Access Compliance Report

Public Rights-of-Way

(Curb Ramps)

Intersection ID: 2834	Main Street: GLEN_MANOR_DR	Cross Street: NOBILITY_CT	Location: SW
ADA ID: 13A717EAADB0	Ramp Type: PerpDiag	Initial Pass/Fail: Fail	Overall Compliance: No
Severity Score: 21.25			
Codes/Mitigation Info/Possible Solution		Field Measurements/Component Compliance

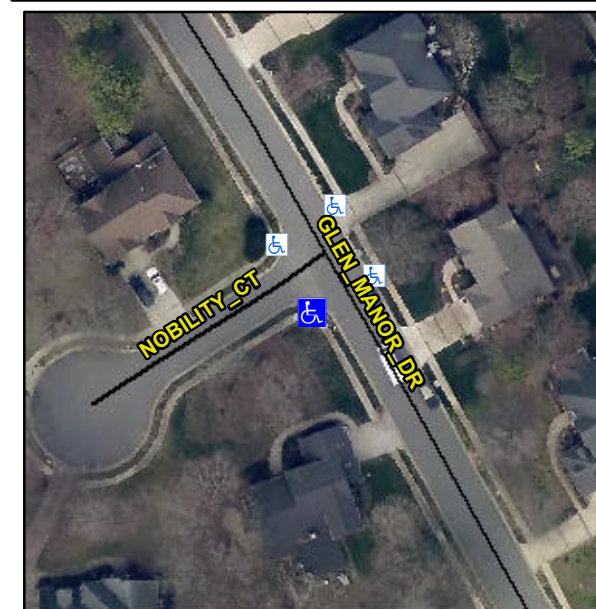
Not Found, R304.5.1, R304.2.2

Compliance	Description	Data	Compliance	Description	Data
N/A	Ramp Length (in)	42.5	No	Ramp Slope (%)	8.5
No	Ramp Width (in)	41.0	Yes	Ramp XSlope (%)	0.2
N/A	Flare Type LT	N/A	N/A	Flare Type RT	N/A
N/A	Flare Slope LT (%)	N/A	N/A	Flare Slope RT (%)	N/A
N/A	Flare Traversable LT?	N/A	N/A	Flare Traversable RT?	N/A
N/A	Landing Length (in)	N/A	N/A	DWS Provided?	N/A
N/A	Landing Width (in)	N/A	N/A	DWS Contrast?	N/A
N/A	Landing Slope (%)	N/A	N/A	DWS Length (in)	N/A
N/A	Landing X Slope (%)	N/A	N/A	DWS Full Width?	N/A
N/A	Landing Curb? (Y/N)	N/A	N/A	DWS Offset (in)	N/A
N/A	Shared Landing?	N/A			
N/A	Gutter Ponding?	N/A	N/A	Gutter Slope (%)	N/A
N/A	Gutter Lip Ht (in)	N/A	N/A	Gutter X Slope (%)	N/A
N/A	Painted X Walk1?	No	N/A	Painted X Walk2?	No
	X Walk 1 Direction	To E		X Walk 2 Direction	To N
N/A	X Walk 1 Width (in)	N/A	N/A	X Walk 2 Width (in)	N/A
	X Walk 1 Slope (%)	4.3		X Walk 2 Slope (%)	0.6
	X Walk 1 X Slope (%)	1.3		X Walk 2 X Slope (%)	1.6

Remove & Replace Curb Ramp With Two New Directional Ramps or Equivalent.
